Draft submission to, amendments to SEPP (Western Sydney Aerotropolis) 2020, Open Space Needs Study, draft Aerotropolis Development Control Plan - Phase 2 and Luddenham Village Discussion Paper

Proposed amendments to SEPP (Western Sydney Aerotropolis) 2020

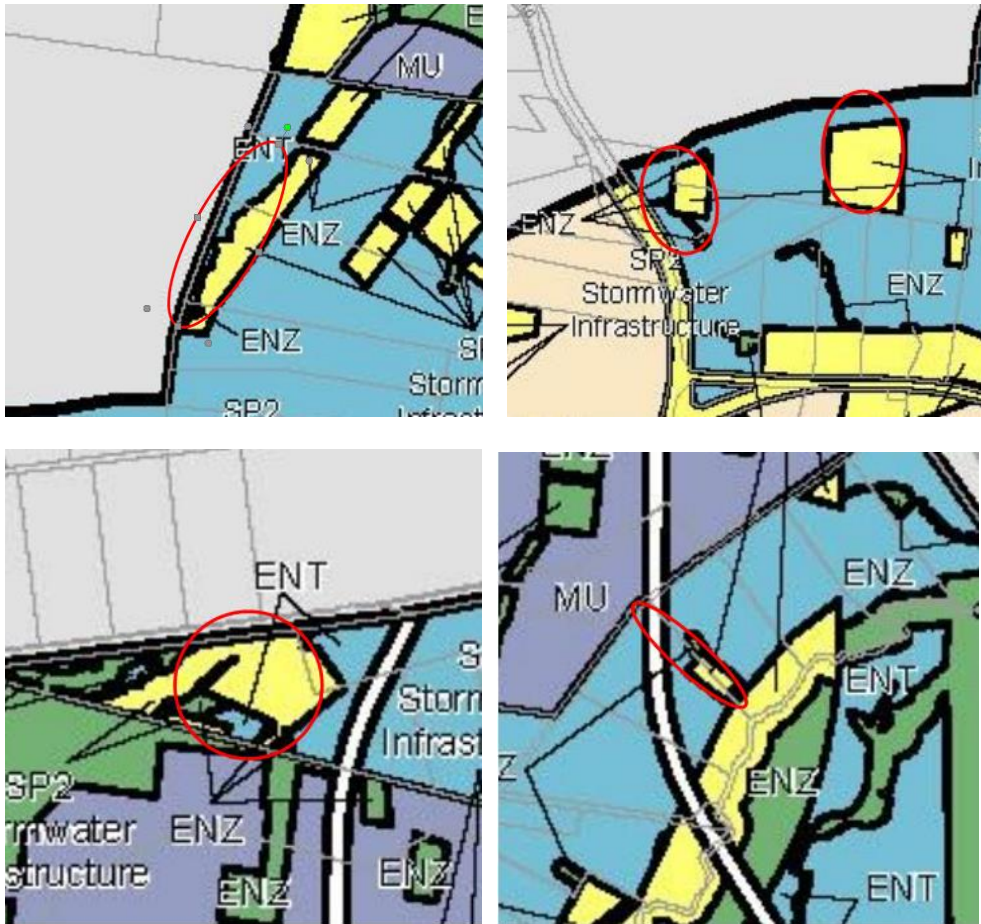
To maintain the transparency of our Environmental Planning Instruments, land identified for open space provision should be clearly identifiable on the Land Use Zoning map of the Aerotropolis SEPP. In the absence of the RE1 Public Recreation zone, the land identified as publicly accessible open space should be zoned as SP2 Publicly Accessible Open Space, or SP2 Local Open Space and SP2 Regional Open Space. We do not support the land being zoned Agribusiness, Enterprise or Mixed Use, if the intention is for this land to be used as publicly accessible open space.

Map 1 Undevelopable Parcels due to location of Stormwater Infrastructure

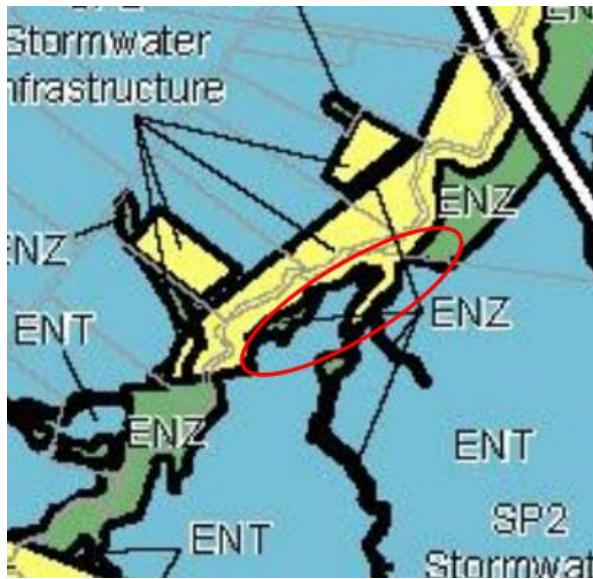
Due to the revision of the open space network, there are several parcels of land in the Northern Gateway Precinct that were previously identified as open space in the Aerotropolis Precinct Plan, and that are zoned Enterprise, that do not meet the minimum block size control of 150m x 150m of the Aerotropolis Precinct Plan due to the location of stormwater infrastructure and rendering these properties not being able to be developed.

The following map highlights the parcels that cannot be developed and the adjoining SP2 Stormwater Infrastructure Zone and the Land Reservation Acquisition affectation should also apply to these parcels of lands.

Land management of these parcels of land will be an issue if they remain in private ownership.
